Historic Site Preservation Board Staff Report

Case No: 5.1032 – HSPB # 3 – Welwood Murray Memorial Library

Application Type: Certificate of Approval

Location: 100 South Palm Canyon Drive

WELWOOD MURRAY MEMORIAL LIBRARY REHABILITATION ELEVATIONS

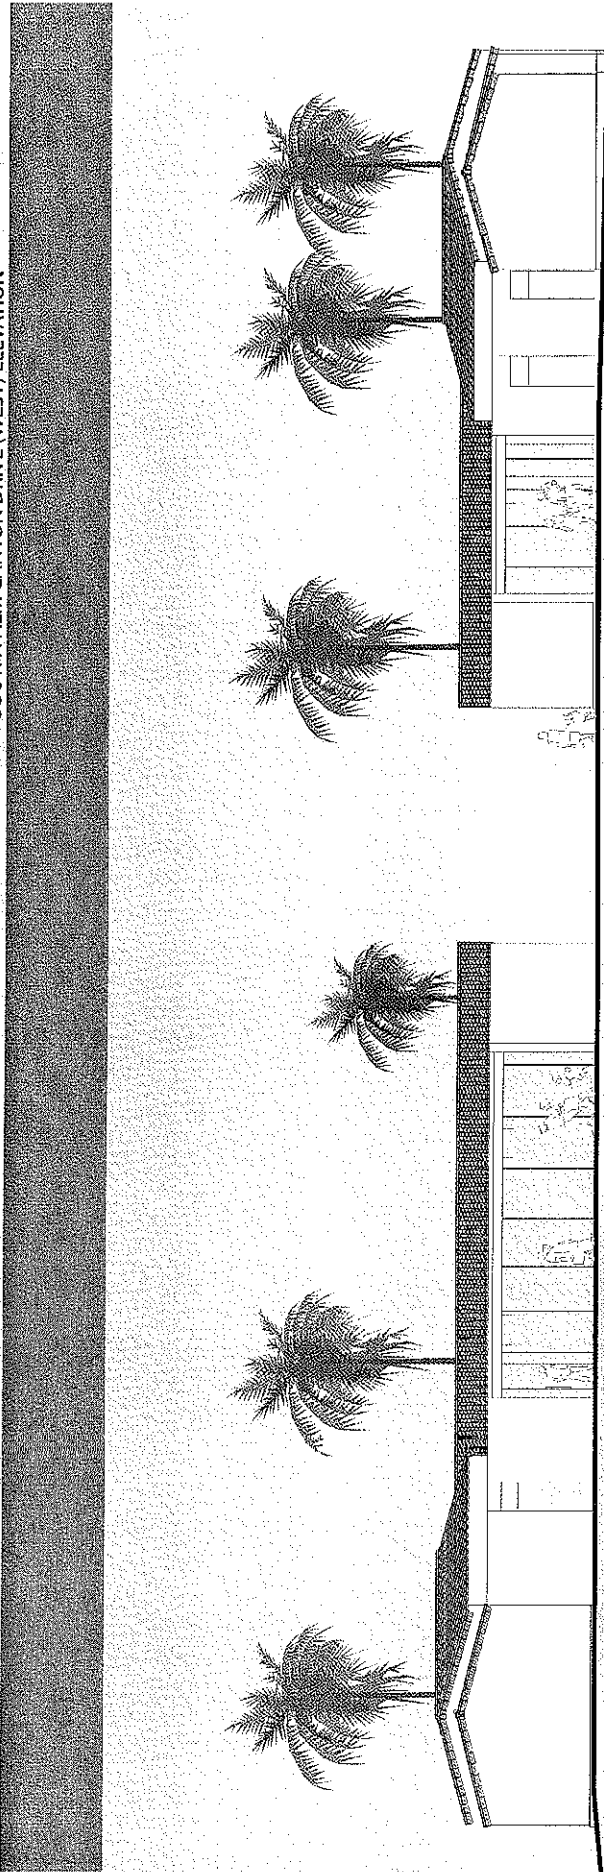
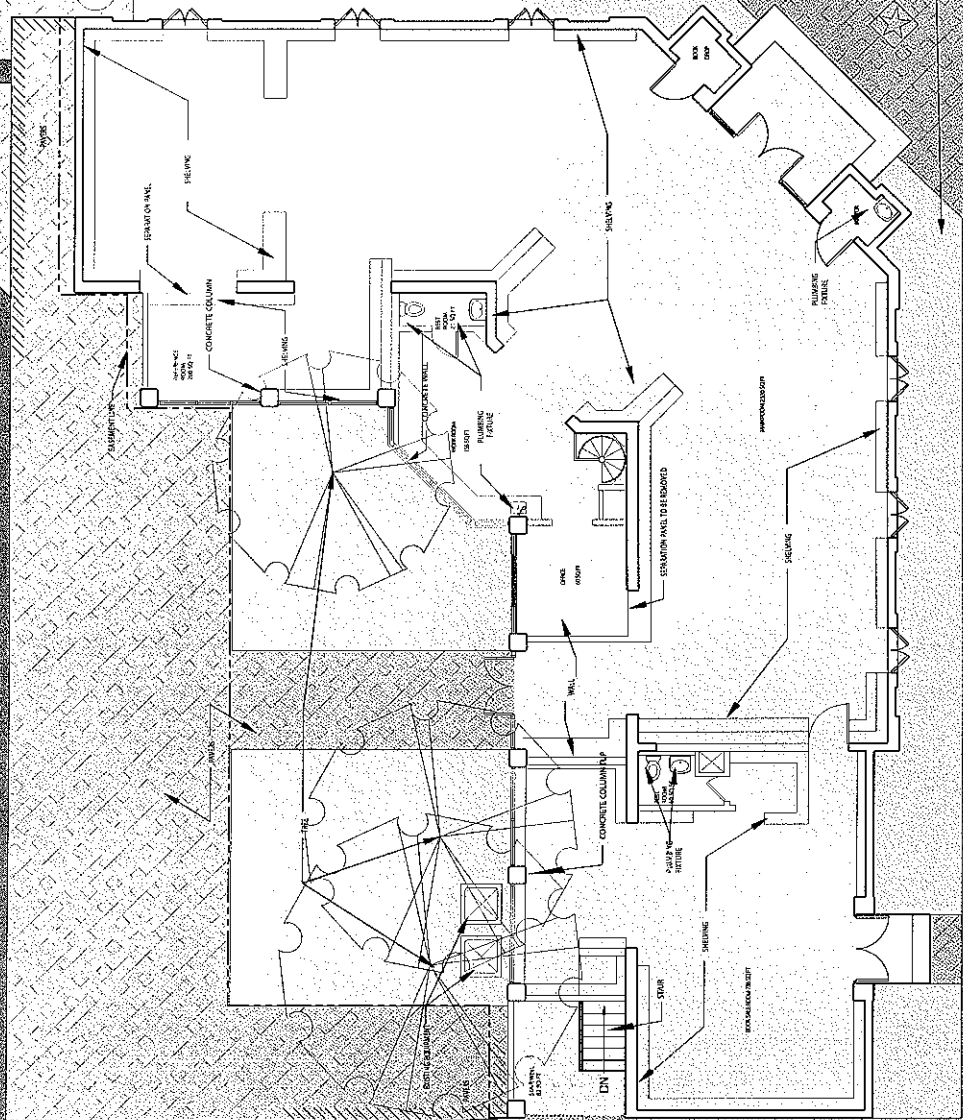
- Better drawings showing the design of the rear courtyard glass system.

Detailed drawings of a mullion-less glass system that allows for clear view to the rear patio and into the building from the patio will be provided.

SECTION A-A 1/2" = 1'-0"

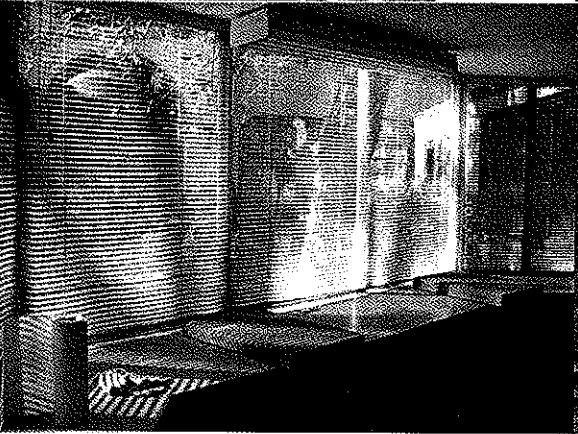
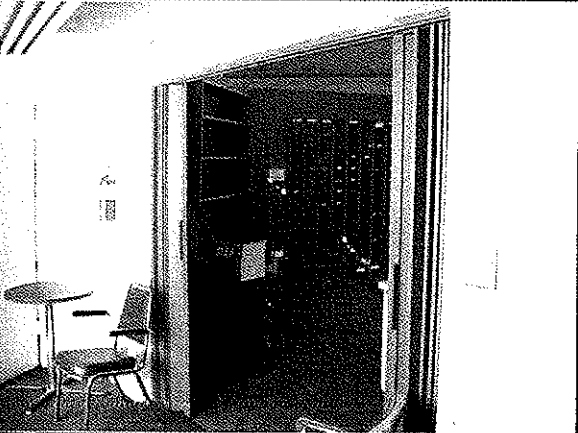
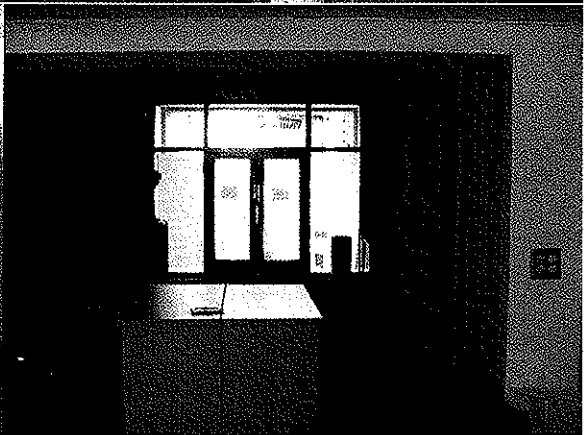
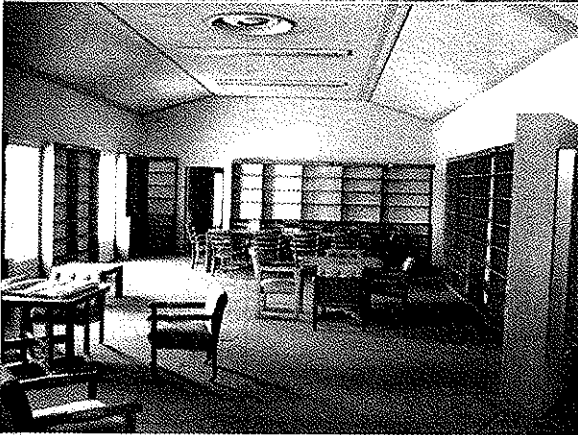
- Better drawings of "Fibertite" roof system.

The applicant believes that there was some confusion over the presentation of the roof system. To clarify, the roof is almost dead flat and the surface will not be seen from anywhere except above it. "Fibertite" is a product name for a single ply rolled roofing the color of which is a light tan and it is a "Green roof". Additional information will be provided at the HSPB meeting.
